# CITY OF CONWAY, ARKANSAS HISTORIC DISTRICT COMMISSION

January 31, 2022 • 5:30pm • 1111 Main Street

## HISTORIC DISTRICT COMMISSION

- A. Block 16 Srygley Addition/500 Block of Oak Street - New Fuel Station (HDR-0122-0176)

2452 - CONWAY, AR  
OAK STREET & LINCOLN STREET  
EXTERIOR ELEVATIONS

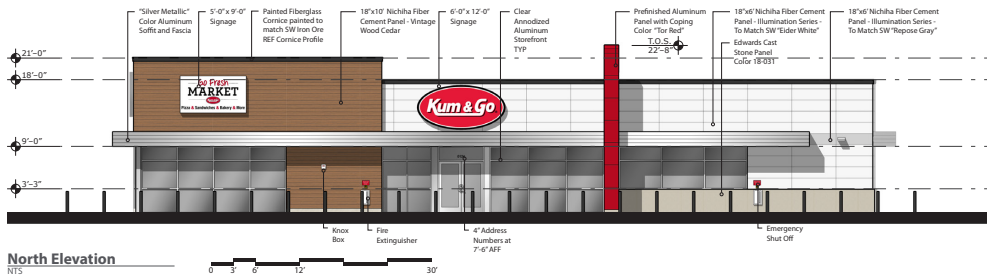
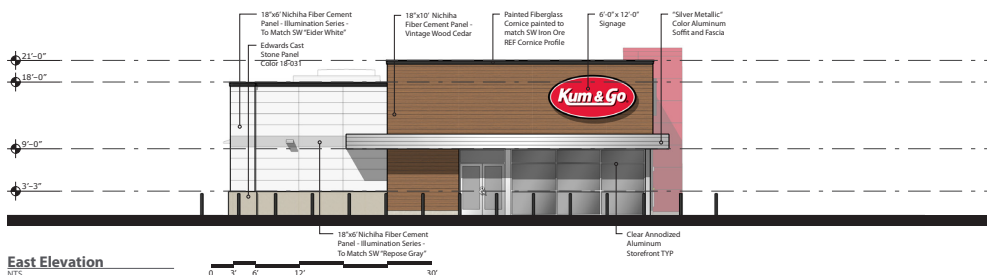
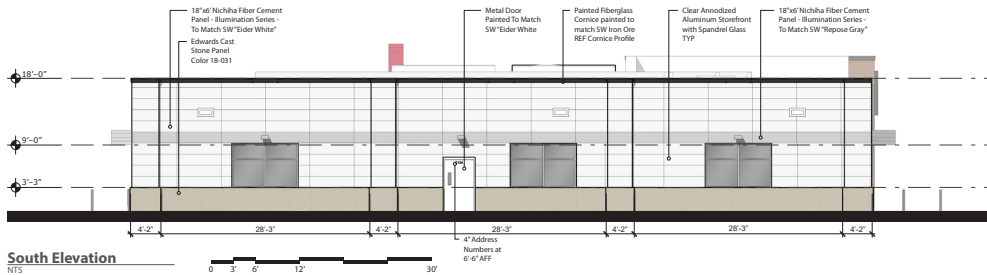
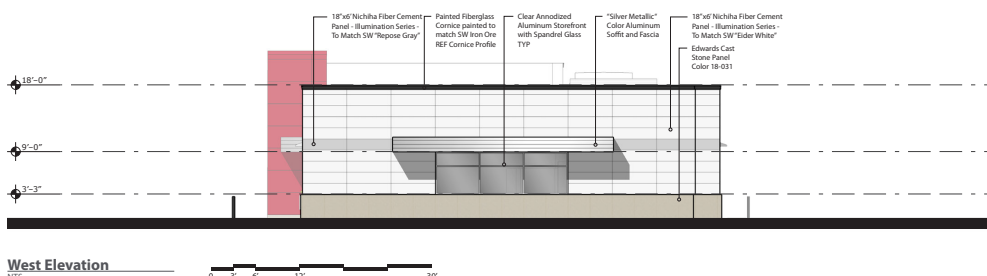
*The façade facing Oak St appears to be rear of the structure with a large flat unbroken façade that is wholly inappropriate to the area.*

*Staff interprets this provision to primarily toward façades facing a street or sidewalk. The Oak St facing façade is proposed to contain 9% windows instead of the required 66%. The Lincoln St façade is proposed to contain 10% windows instead of the required 66%. The Ingram St façade is proposed to contain 20% windows instead of the required 66%. The proposed design appears to have been developed without consideration given to properly addressing Oak St.*

Based on the submitted architectural plans it appears the windows facing Oak St will not be transparent. It is unclear regarding glazing on the other facades.

The materials proposed for structure are not appropriate to the district. The structure includes no proposed brick and appears to be a standard prototype Kum & Go. It appears no effort was made on the part of the applicant to comply with building material requirements for the district.

The structure is oriented such that a security door is the entry facing Oak St. It appears no effort was made on the part of the applicant to comply with the requirements of the district.

Staff recommends denial of the application. The architectural design of the structure fails to meet numerous requirements of the ordinance and it does not appear consideration of the requirements of the HDC or district were given in design.
